Subject: RE: Major Projects – New Request for Advice - Residential Flat Building - Carrington Rd, Castle Hill (SSD-83112728) (The Hills Shire)

Please find below comments from Council's Traffic Section:

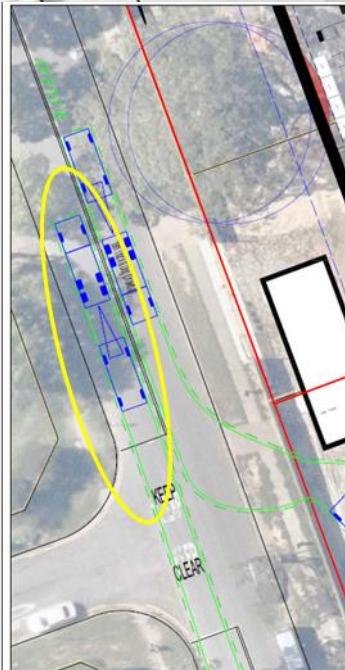
- *The Civil Engineering and Landscape Plans propose filling the redundant cul-de-sac in Sexton Avenue with landscaping, including a footpath and a "drop-off zone". The area appears to remain as Council land. As advised in the pre-lodgement traffic note, the applicant should consider acquiring the cul-de-sac, otherwise, any landscaping on Council road reserve must be easily maintainable by Council or maintained by the proponent in perpetuity. The proposed paved "drop-off zone" adjacent to the footpath is not supported due to insufficient clearance for vehicle swept paths along the bend. The indented parking lane should continue around the curve, with garden beds positioned in accordance with the Showground Precinct Public Domain Plan and Verge Treatment Details. The footpath alignment should be straightened, which will require removal of the affected street trees. Council's Landscape Team has advised that they raise no objection to the removal of the trees at this location. Refer to sketch below (indicative only).*

- *Should the proposed development be approved, the following traffic conditions should be included in the development consent:*
 1. *A revised plan for the public domain works within the redundant cul-de-sac in Sexton Avenue must be submitted prior to the issue of Construction Certificate. The revised plan is to include additional indented parking bays, realignment of the footpath, and landscaping provisions that adequately address traffic, pedestrian, and landscaping requirements.*
 2. *Prior to the issue of Construction Certificate, the applicant must consult with Council's Traffic and Roads Management Team regarding any required parking restriction signage. If signage is required, a signage plan must be prepared and submitted as part of the Section 138 plans for Council approval. All approved signage must be installed by the applicant at no cost to Council.*
